FINAL PLAT
THE LEGACY ADDITION
AN ADDITION TO WICHITA SEDGWICK COUNTY, KANSAS

Re: S/D 98-55 -- Final Plat of THE LEGACY ADDITION

Re: S/D 98-55 -- Final Plat of THE LEGACY ADDITION

CASE NUMBER: S/D 98-55 - THE LEGACY ADDITION (formerly SOUTH PARK 3RD ADDITION)

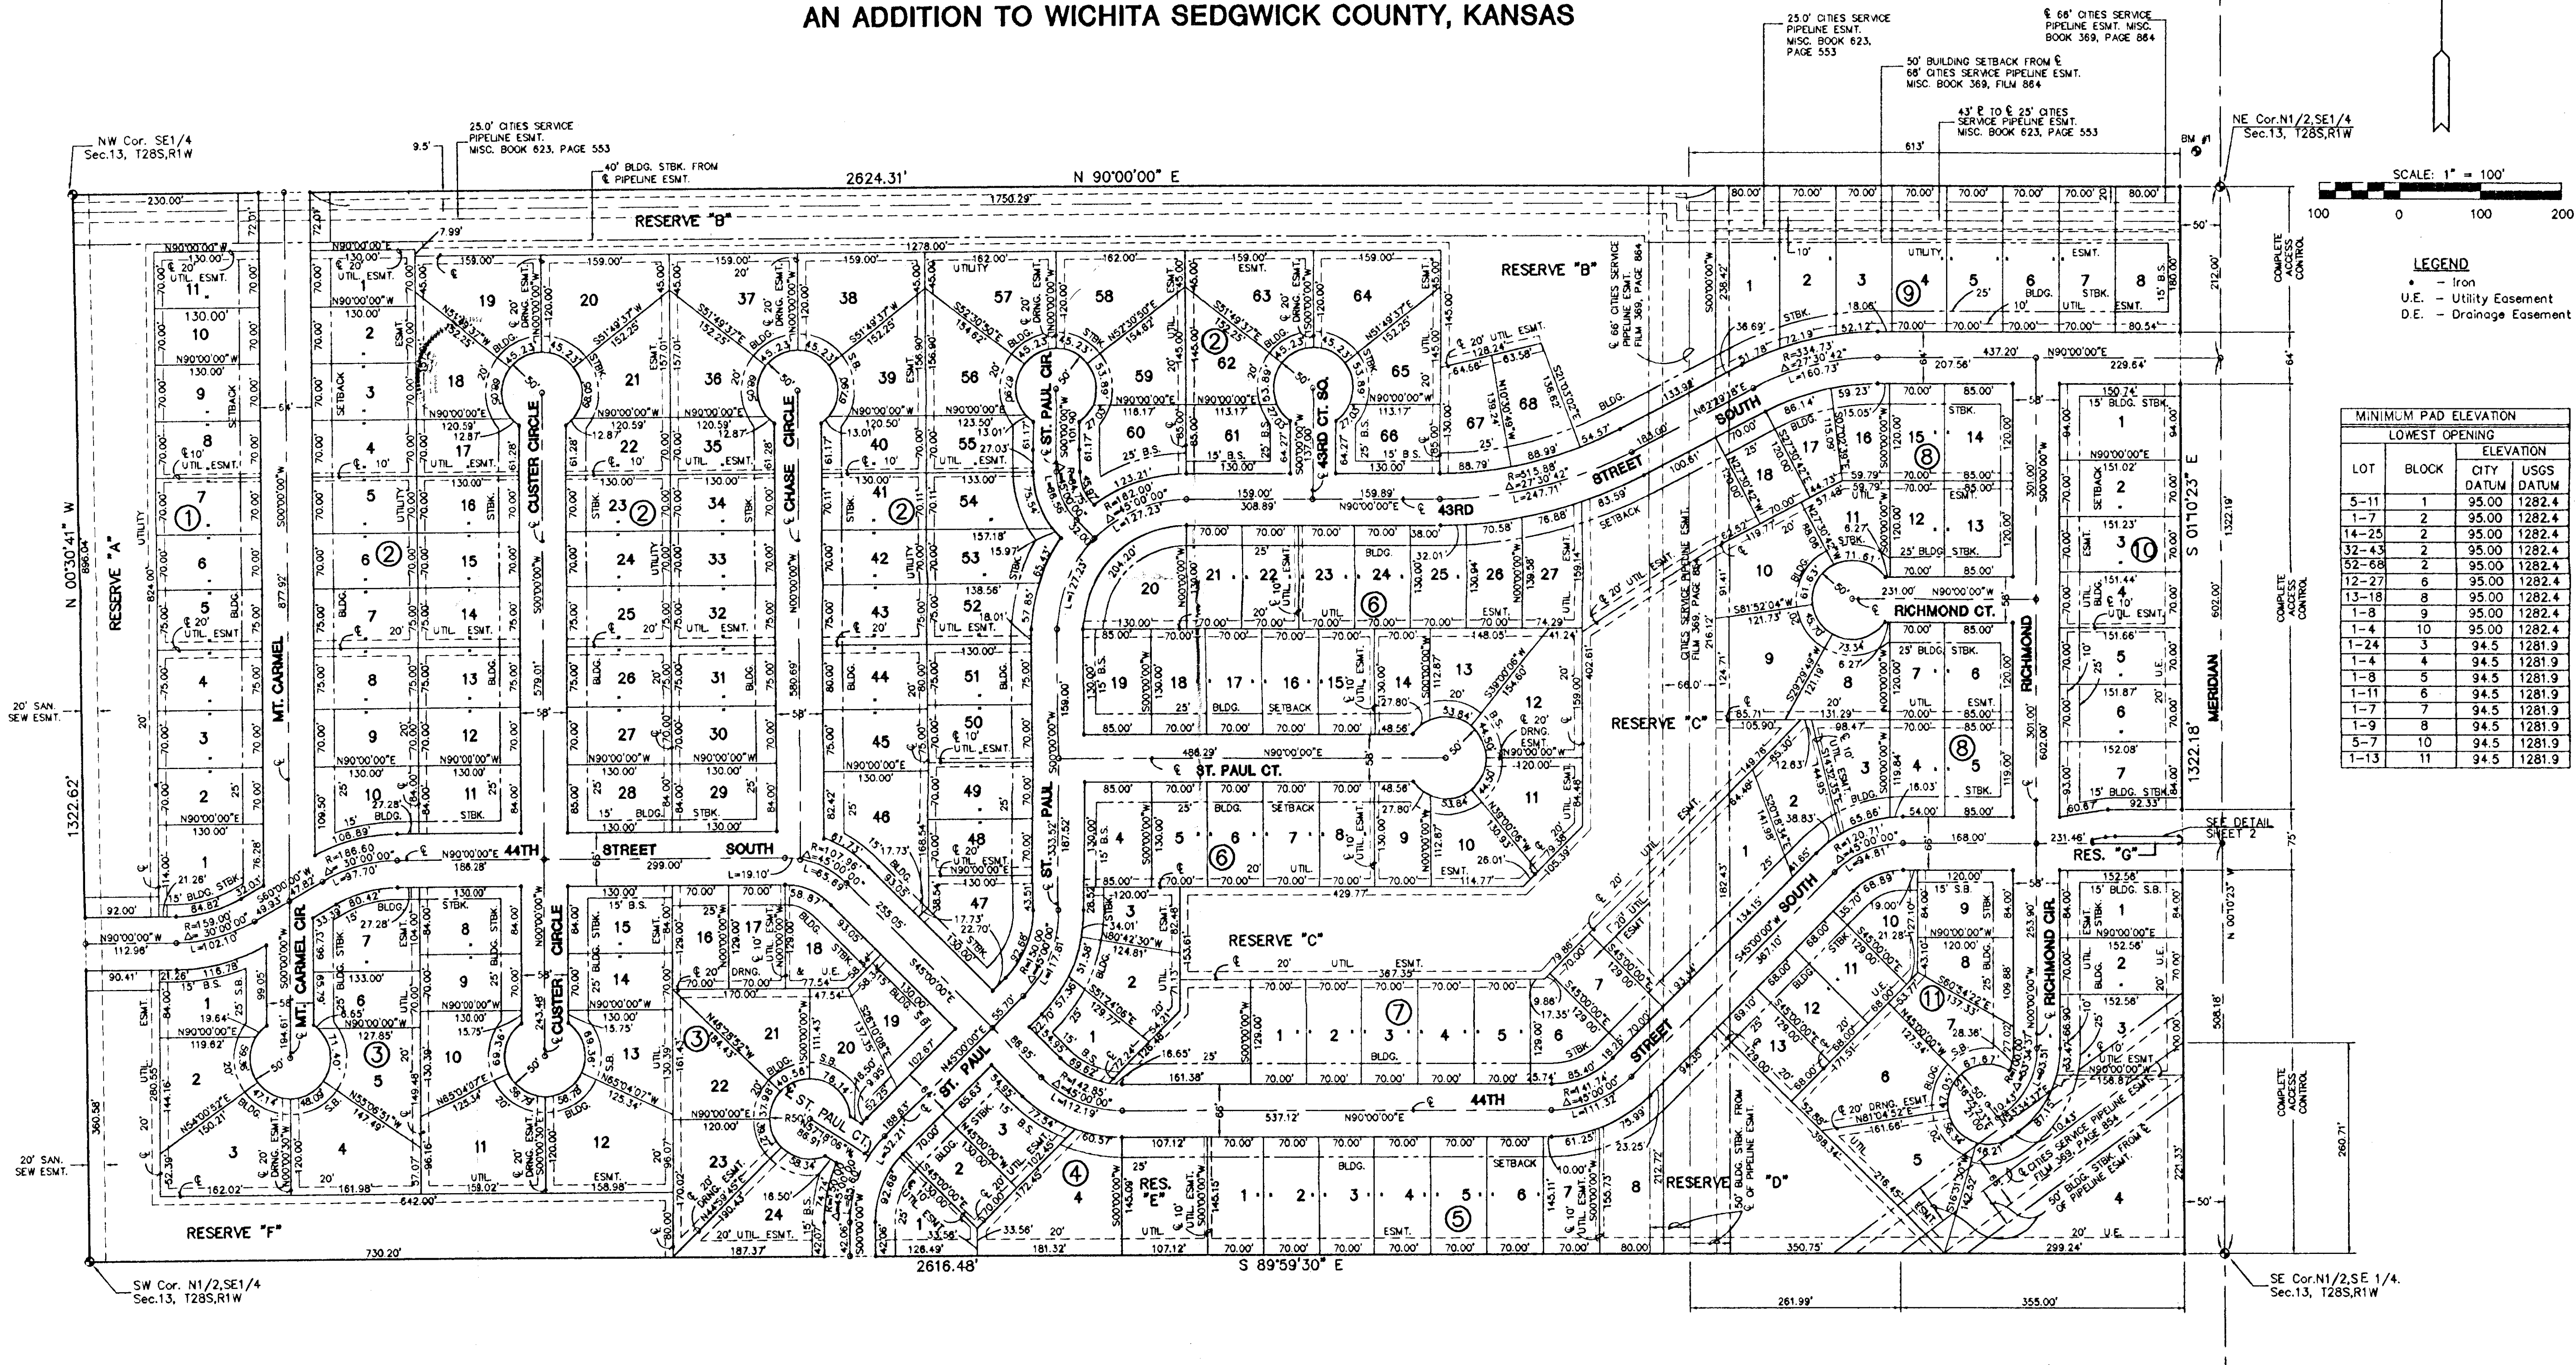
- A. The applicant shall guarantee the extension of City water and sanitary sewer to serve the lots being platted. City Engineering needs to indicate if any additional guarantees are required. A respread agreement will need to be submitted for any existing special assessments.

- C. City Engineering needs to comment on the status of the applicant's drainage plan. The drainage plan is approved. The lots adjacent to the pond and drainage ditch need minimum building pad elevations.

- D. The applicant shall guarantee the paving of the proposed interior streets. This guarantee shall include the paving of 44th St. South to a collector status. As a collector street, sidewalks will be required along both sides of 44th St. South. Sidewalks will be required along one side of all 64-ft streets (Mt. Carmel, Chase, St. Paul and 43rd St. South).

- G. The tie point at the southeast corner of the plat should be revised to reference the "SE 1/4".
- H. The applicant shall submit a copy of the instrument which establishes the pipeline easements on the property, which verifies that the easements shown are sufficient and that utilities may be located adjacent to and within the easements.

- J. Lot 1 through 8 of Block 9 exceed the lot depth-to-width standard of 2½ to 1. A waiver from this provision will be needed for approval of the plat.

- M. A guarantee shall be provided for the installation of a temporary cul-de-sac for the termination of Mt. Carmel. The right-of-way dedication shall be provided by the plat or by separate instrument, with the vacation of the temporary cul-de-sac being effective upon the extension of Mt. Carmel northward.

- N. Traffic Engineering needs to comment on the need for improvements to Meridian. Traffic Engineering requests two temporary decel lanes for southbound traffic along Meridian.

- O. Fire Department needs to comment on Mt. Carmel which is 800 feet in length, exceeding the 600-ft standard imposed by the Subdivision Regulations. The length of Mt. Carmel is acceptable since it is a stub street. A temporary turnaround is required.

- Q. Fire Department needs to comment on the plat's street names. It would appear that St. Paul Circle should be renamed St. Paul Court. *Fire Department has contacted the Applicant regarding revised street names. Chase shall be renamed St. Paul. Chase Court shall be renamed St. Paul Court. 43rd Street South Court shall be renamed 43rd Court South.* \

- Y. The representatives from the utility companies should be prepared to comment on the need for any additional utility easements to be platted on this property. *KG&E and Southwestern Bell has requested additional easements which have been denoted on the final plat.*
